**MEMORANDUM VIA ELECTRONIC MAIL**

**RE:** City of Creede  
307 South Loma Street  
Preliminary Engineer Evaluation

**STORMWATER MANHOLE AND PIPE DETAIL  
ENGINEER EVALUATION  
CITY OF CREEDE**

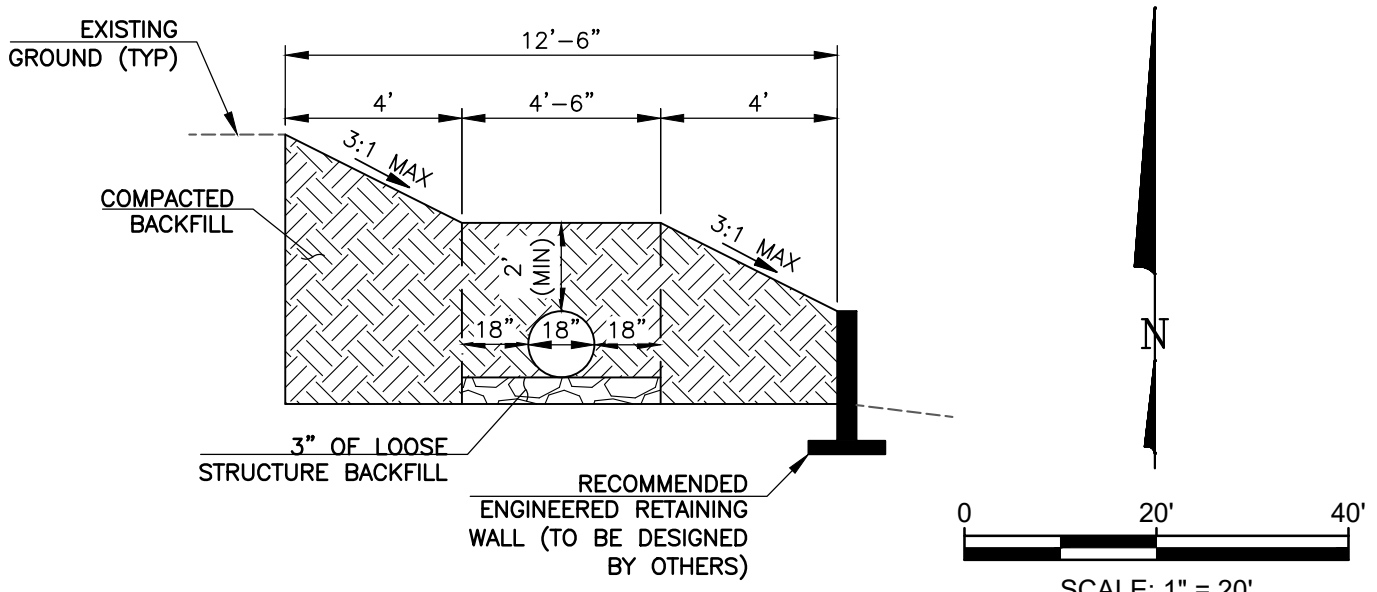
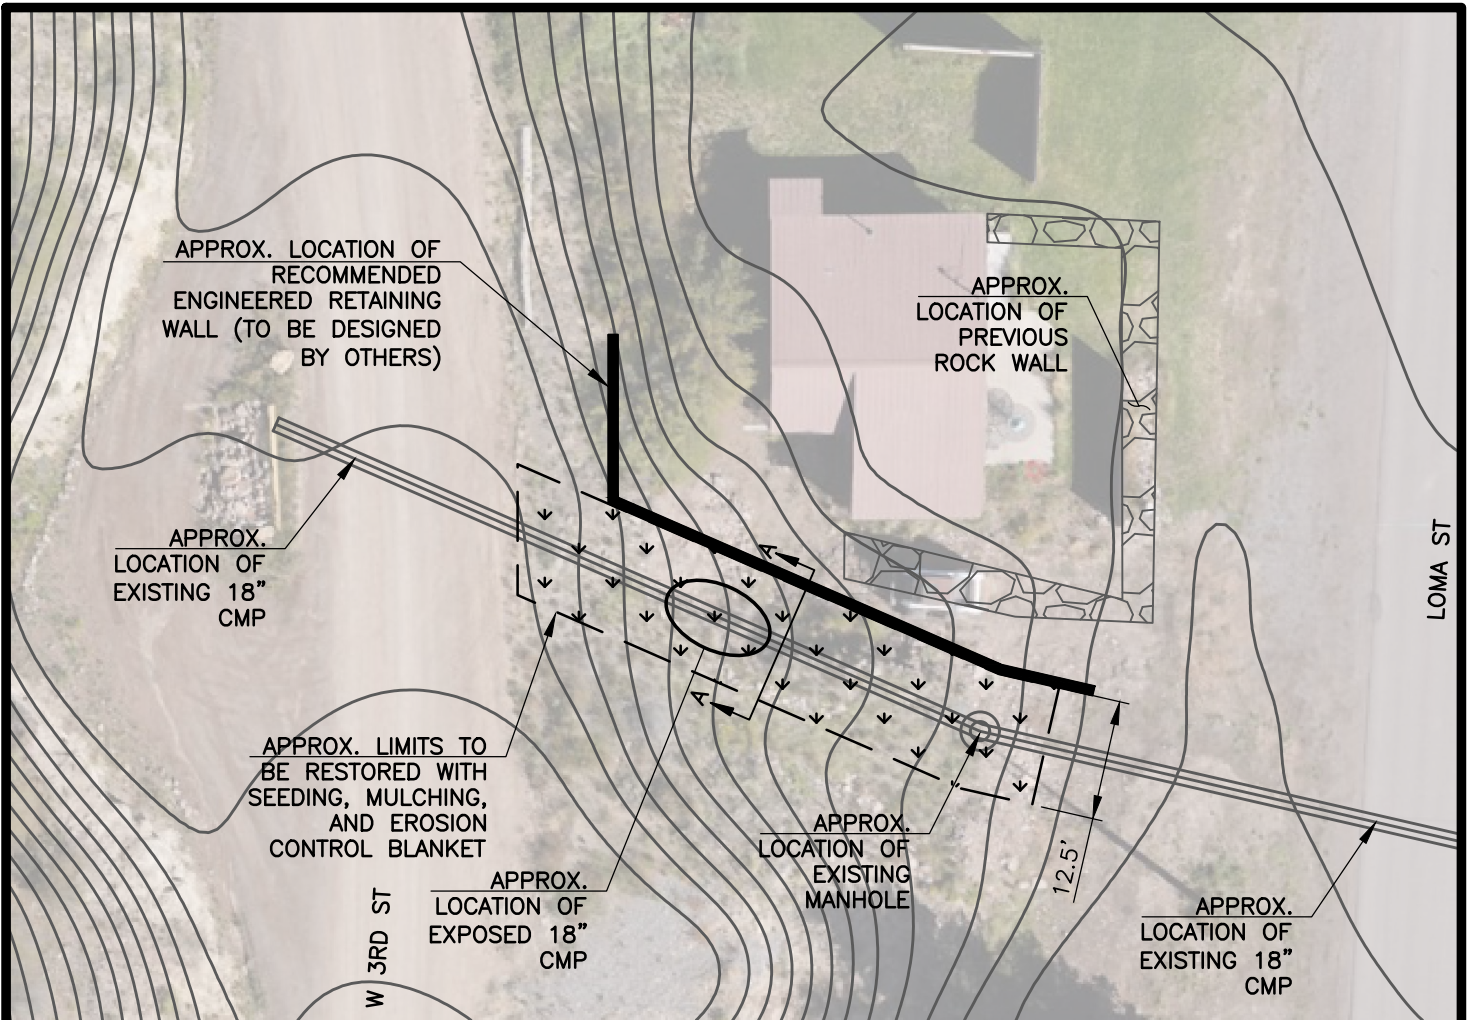
- Ground around stormwater manhole shall be restored with compacted backfill at a maximum slope of 3:1 for both cut and fill in all directions. Manhole lid shall not be set at or below surrounding grade, but a minimum of 6-inches above grade.

- Ground adjacent to the exposed section of pipe shall be restored with compacted backfill in accordance with the attached provided detail.
- Ground above the exposed section of pipe shall be restored with compacted backfill and provide a minimum of 2-feet of cover from the top of pipe in accordance with the attached provided detail.

- The existing stormwater structures shall rest on 3" of loose structure backfill in accordance with the attached provided detail.
- The site shall be graded so that stormwater is directed away from the manhole.
